## MICHIGAN DEPARTMENT OF TRANSPORTATION

## SPECIAL PROVISION FOR REVISIONS TO SHOP CLEANING AND COATING STRUCTURAL STEEL

Figure 1: Acceptable final paint over hot-dip galvanizing.

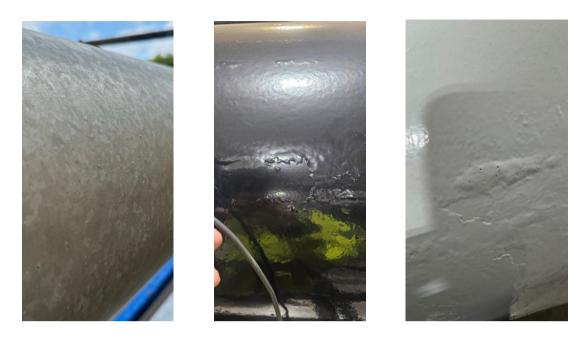
Zinc high spots are defined as surface imperfections that are visible on the parts after painting (liquid and powder coat). The following photos are intended to provide a visual standard:
